## **New Jersey Department of Transportation**

### **TRENTON HEADQUARTERS SITE INSPECTION**

#### **Status Update**

**October 2010**

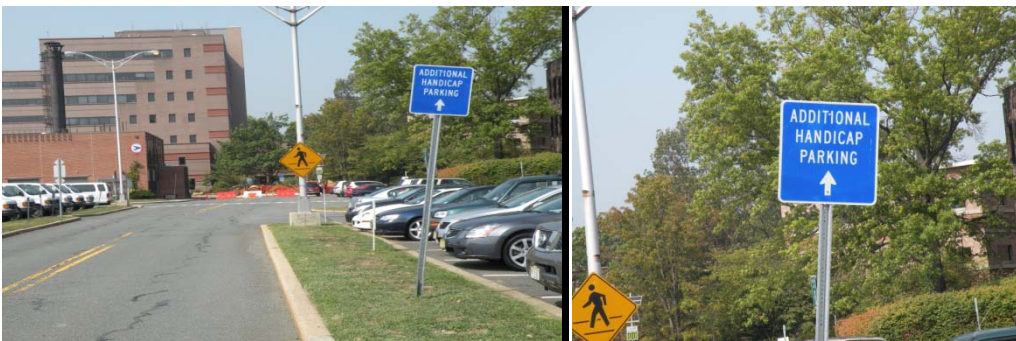
- There are no Handicapped Parking spaces on the south side of the F & A building. It was suggested that DOT either develop a quantity of parking spaces or place signs directing drivers to a Handicapped Parking area.

**AFTER:** Signs were installed on 5/21/10 directing drivers to Handicapped Parking area.
